February 3, 2025

Reference: 2 East Main Street
Southborough, Massachusetts
EDC Job No.: 3650

We are writing to address the Peer Review Comments as provided by Fuss & O'Neil dated January 9, 2025. The following addresses each point raised in their review letter with EDC's response in red.

Sheet Title:
 Proposed Draft Floor
 Layout Plans
 A1.0

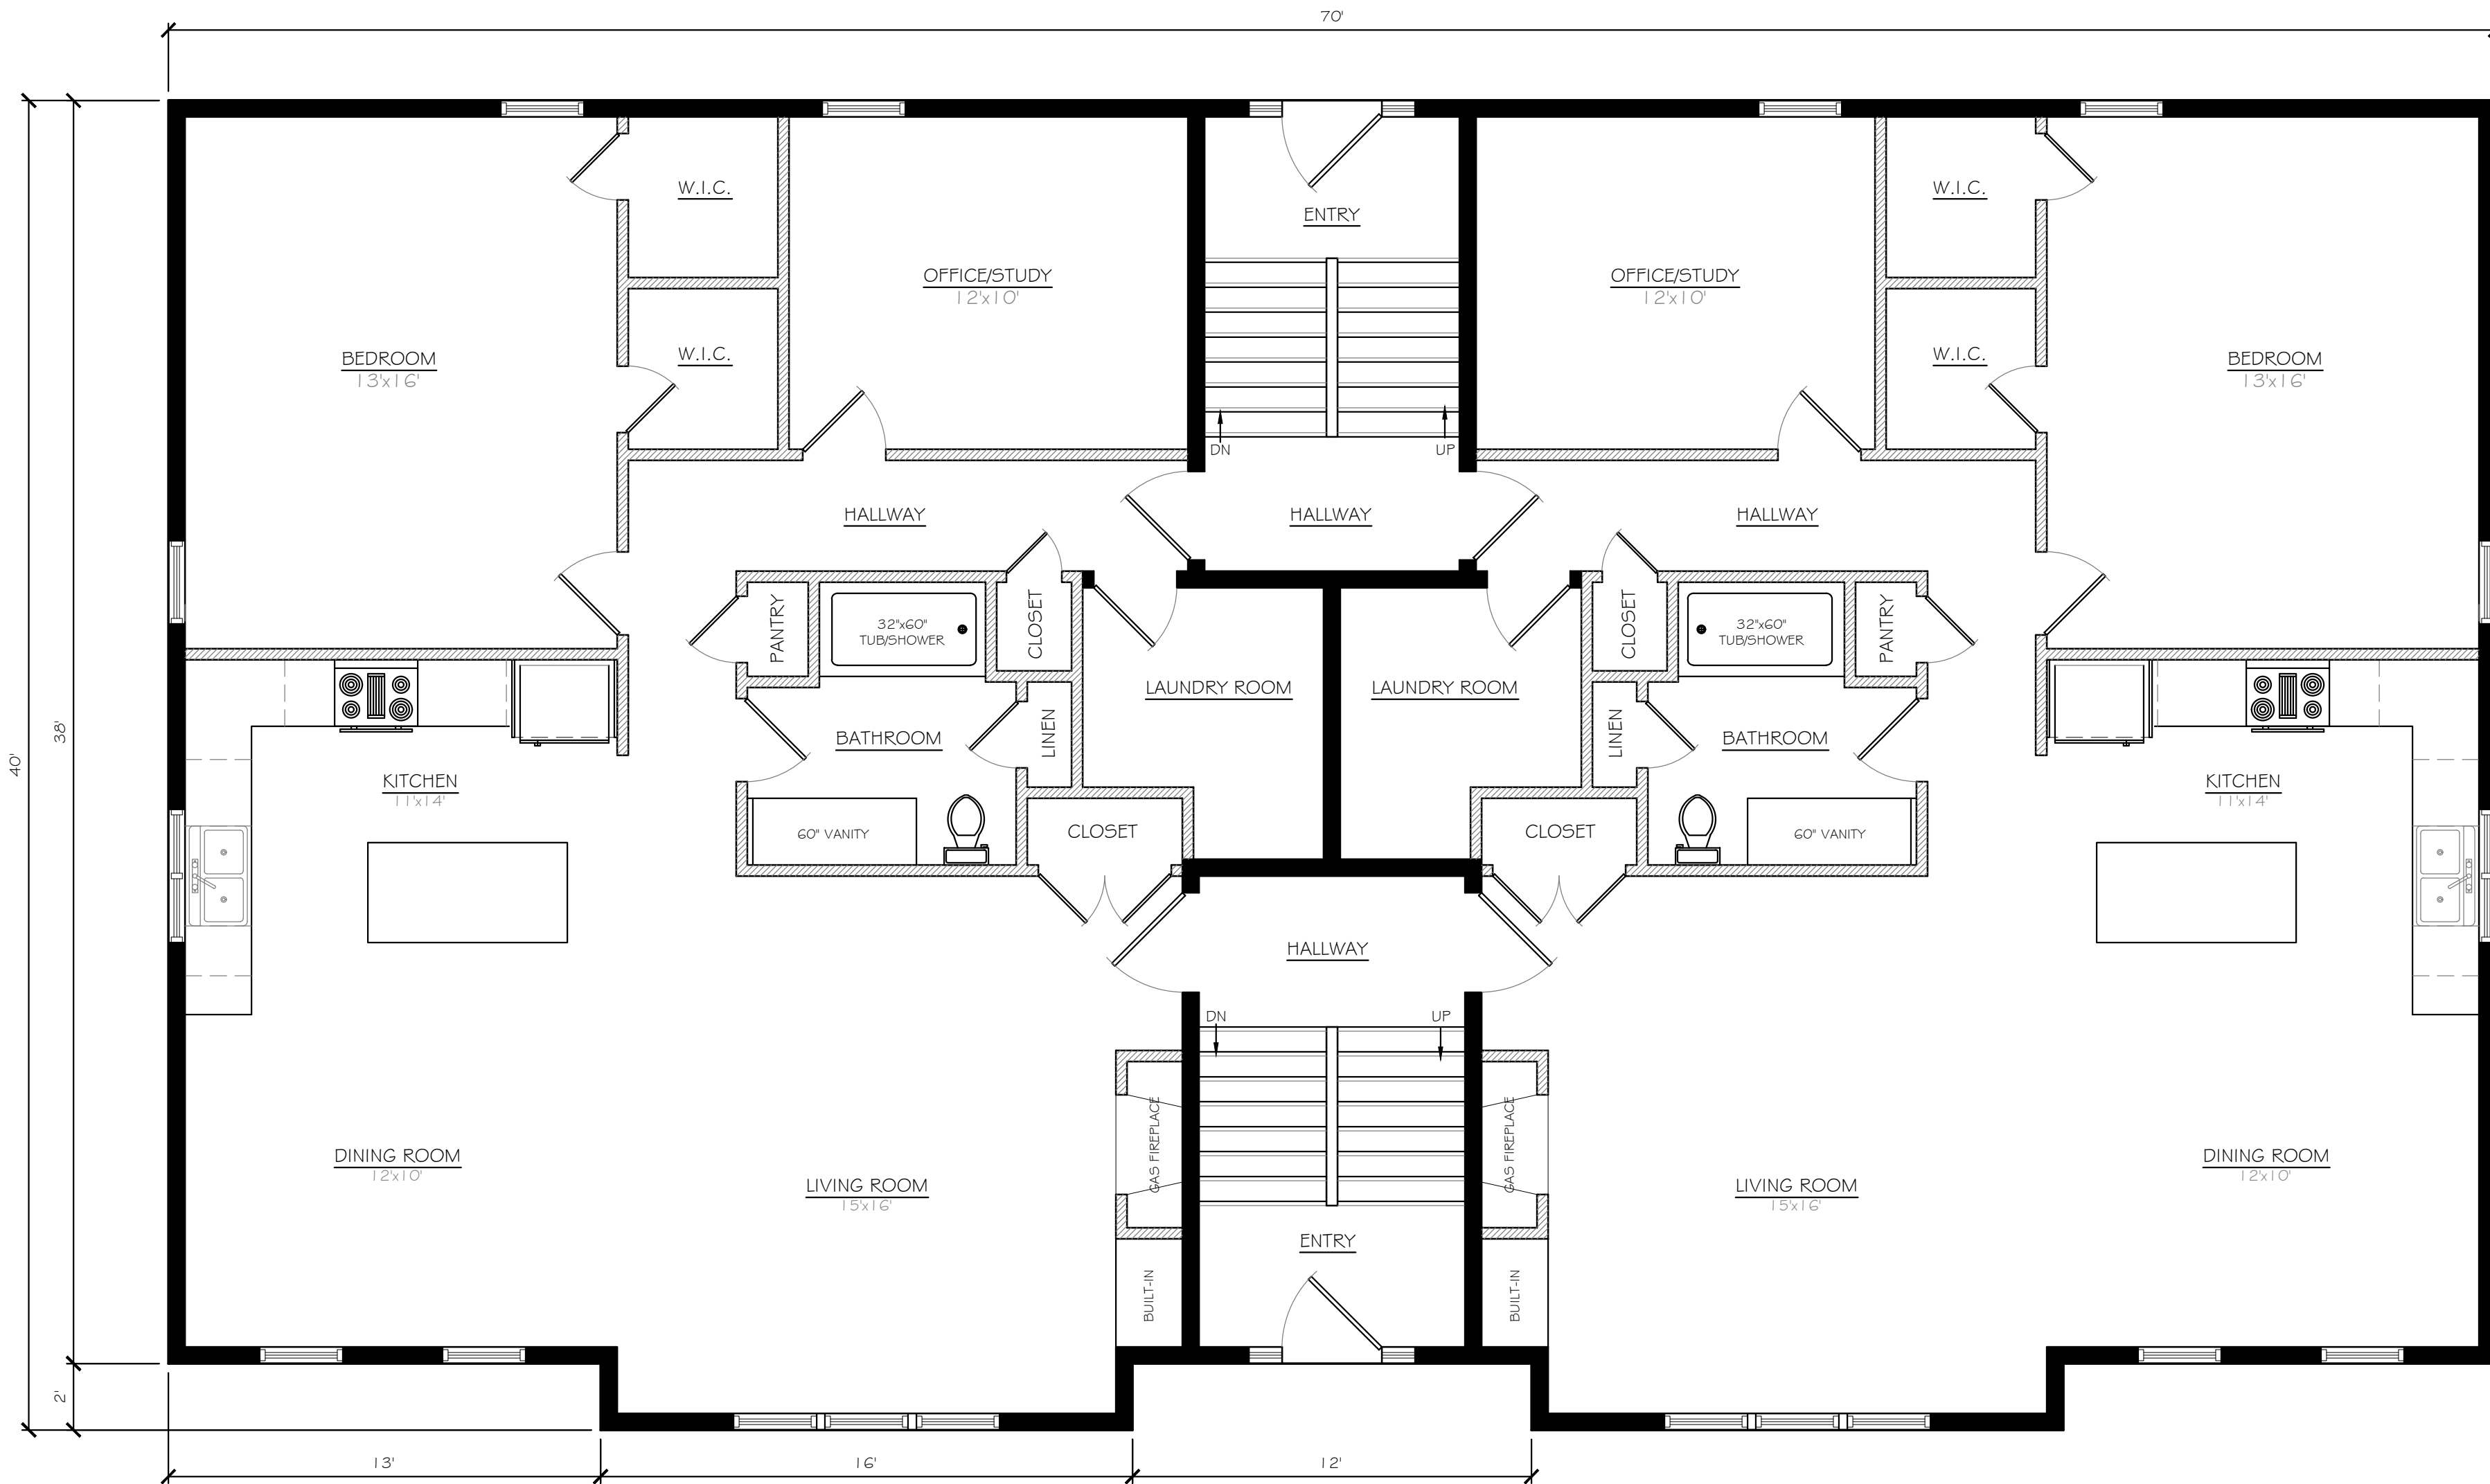
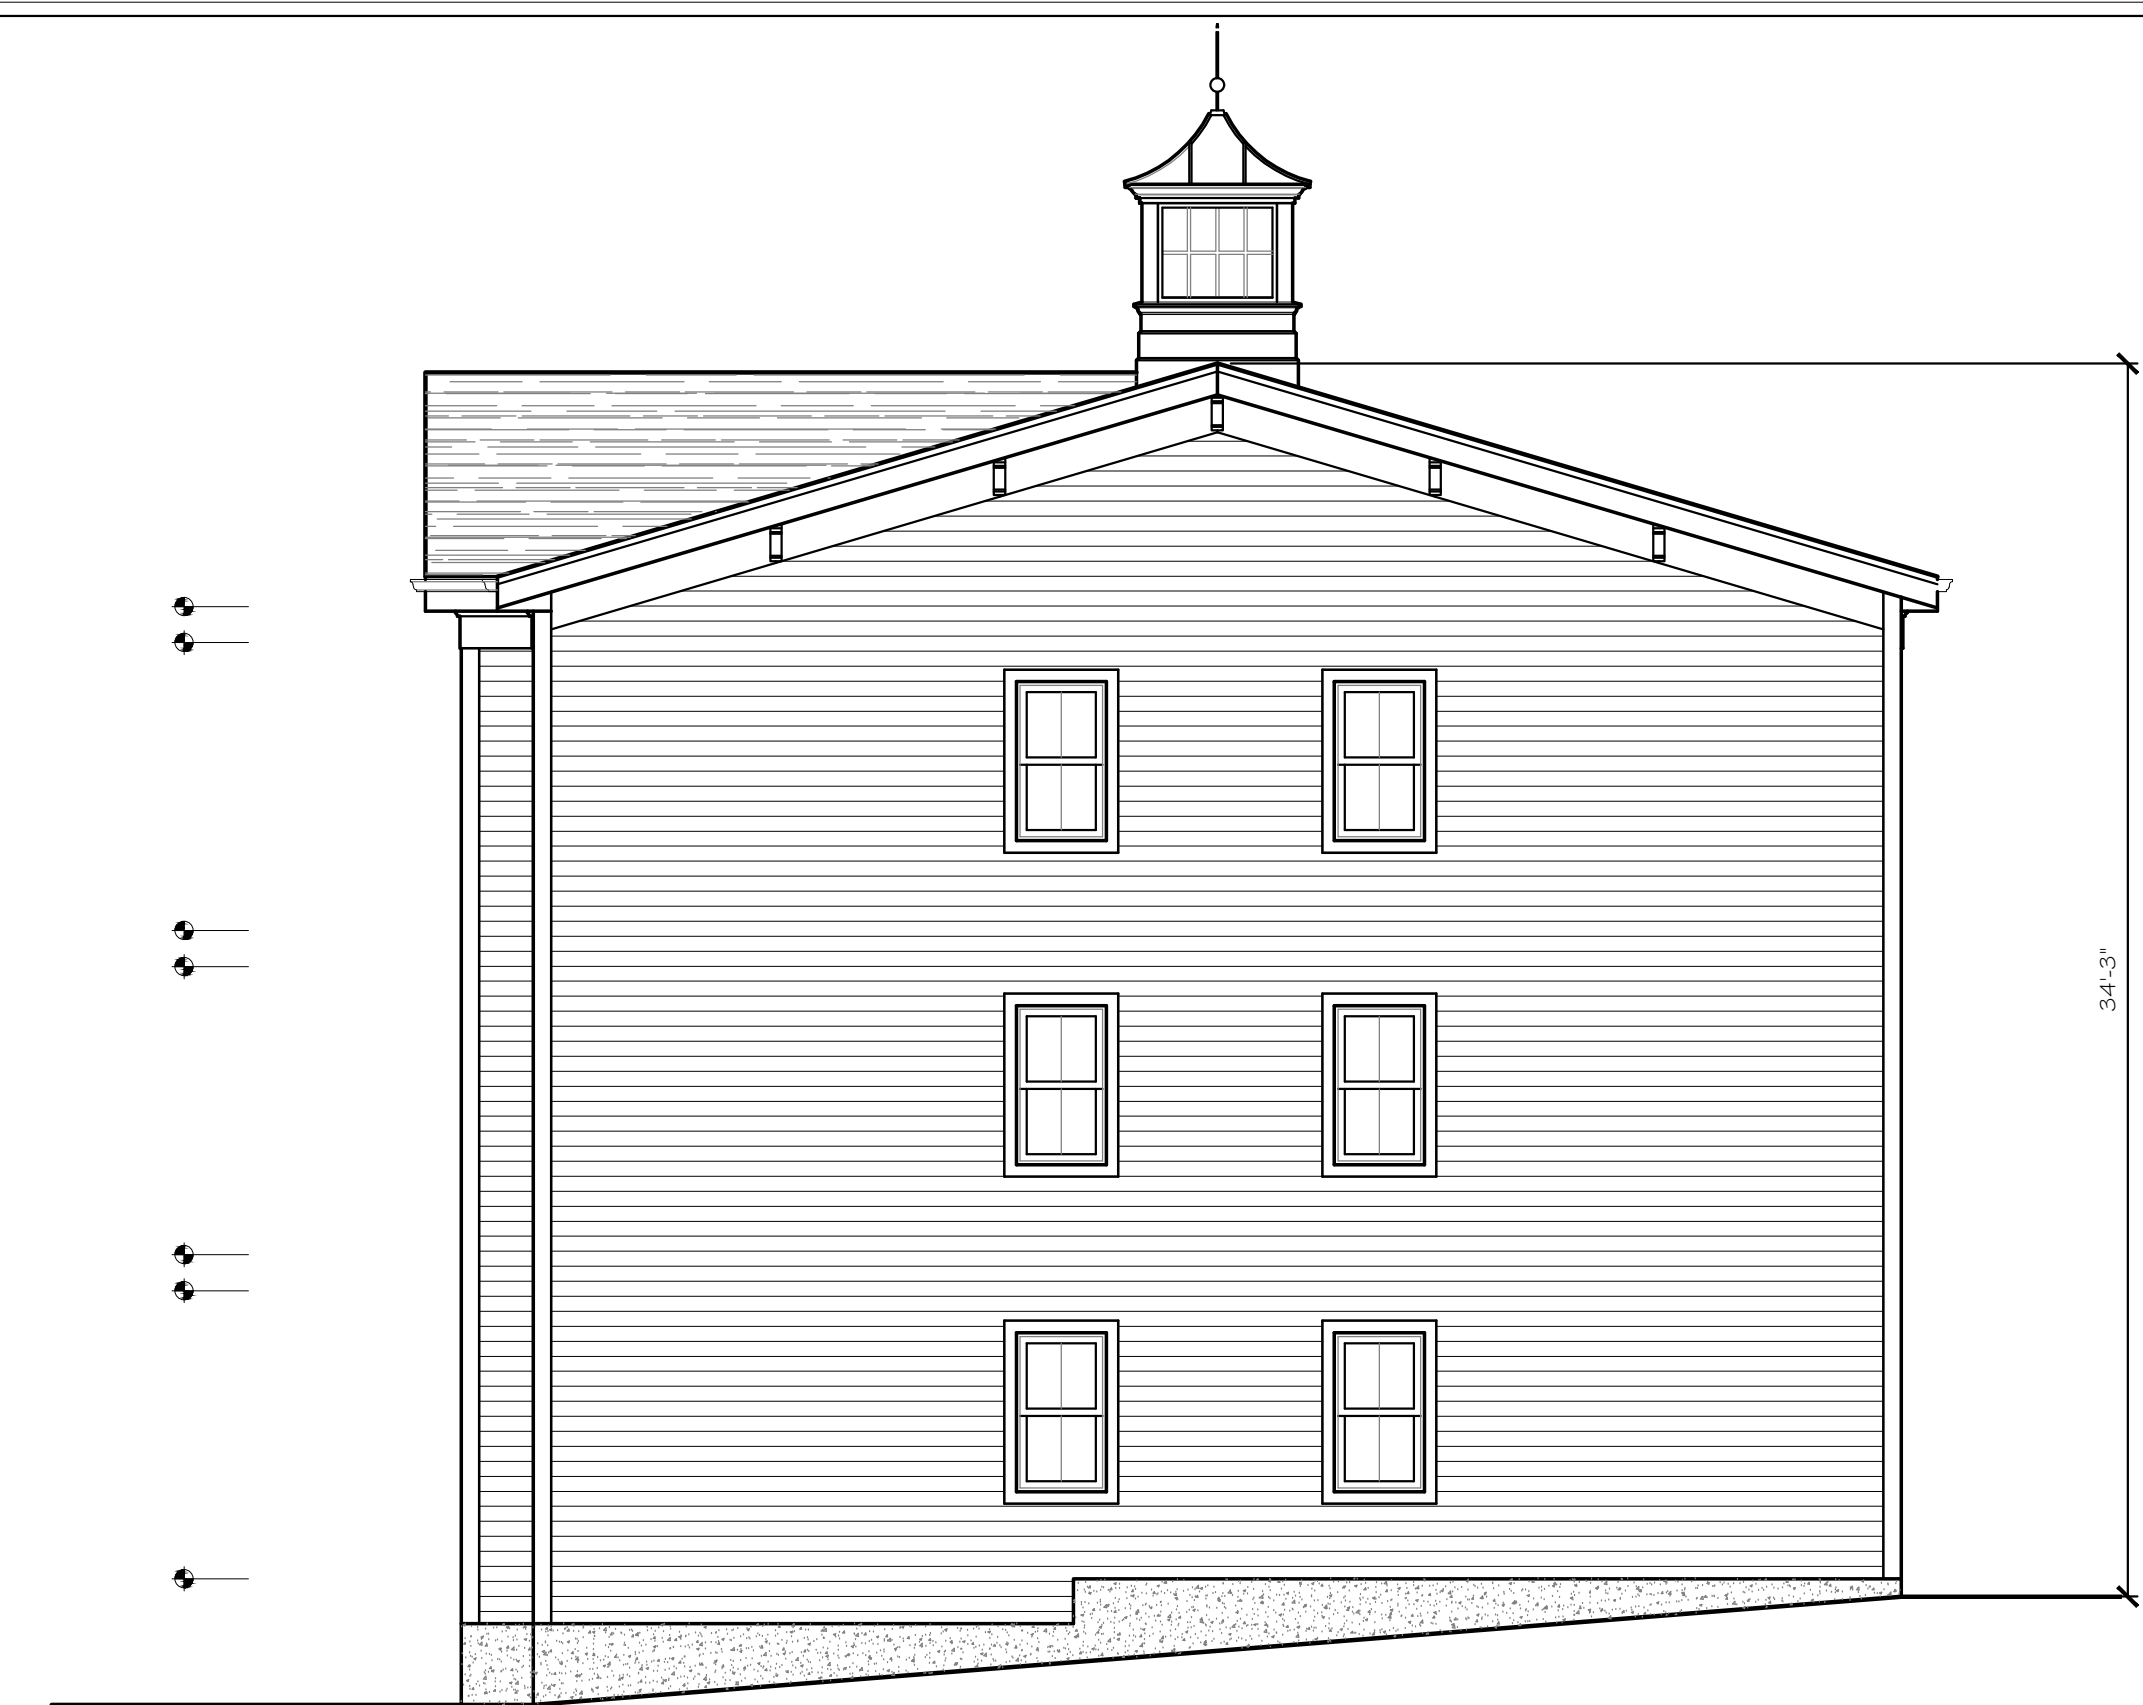
2. Per Section 174-8.12 F (8)(a) of the Zoning, maximum building height of 35 feet and three stories. In review of the Site Plans, the Building Layout sheet shows from ground to roof is 33'-3 1/4" tall, however, does not include the cupola on the top of the building. The

Plan does not include a dimension for the cupola. A dimension of the cupola must be provided. The Applicant shall review the total building height, which includes the cupola, to ensure it's under the 35 feet height limit.

19. There is a discrepancy between building footprint shown on the Site Plans and the Architectural Plans In reviewing the Proposed Site Plan, the Site Layout shows the proposed building as 40'x75', however, the architectural plan shows the building as 44'x75'. There also appears to be a third floor, most likely an attic or similar smaller space, that is unclear on purpose or total square footage. Please clarify the building footprint, gross square footage, and third floor information.

The building has been modified to better address the single-use residential character while retaining the 3-story elevation that includes the copula which does not count towards building height as provided in the definition of Height outlined in the Southborough Zoning By-law.

The architectural plan has been updated to reflect the single-use multifamily structure, and the site plan supports the 40'x70' overall building limits.
